IMPORTANT SAFETY RECALL NOTICE

**NHTSA RECALL NO. 13V-543 SCHOOL BUS
NHTSA RECALL NO. 13V-545 NON-SCHOOL BUS**

SUBJECT: RECALL R13WR FRONT SUSPENSION BOLTS MAY BREAK

Front Suspension Rear Shackle Bolts

Bolt head with “ZY” code

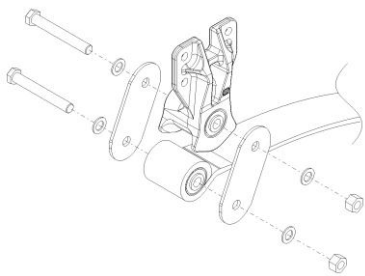
The front suspension rear shackle bolts may break as a result of hydrogen embrittlement which may have occurred during the bolt manufacturing process.

Inspect the front suspension rear shackle bolts for “ZY” code on the bolt head. Replace any rear shackle bolt that has the “ZY” code.

1. Park bus on a level surface, apply parking brake, turn off ignition, remove ignition key and chock rear wheels.
2. Underneath the bus, locate the front suspension, rear shackle bolts on the right (curb) side and left (drivers) side of the chassis.
3. Inspect the head of the bolt for “ZY” code. If there is no “ZY” code on any of the four bolts, no further action is required. Document the bolt head code for all four bolts on the enclosed R13WR Inspection Sheet.
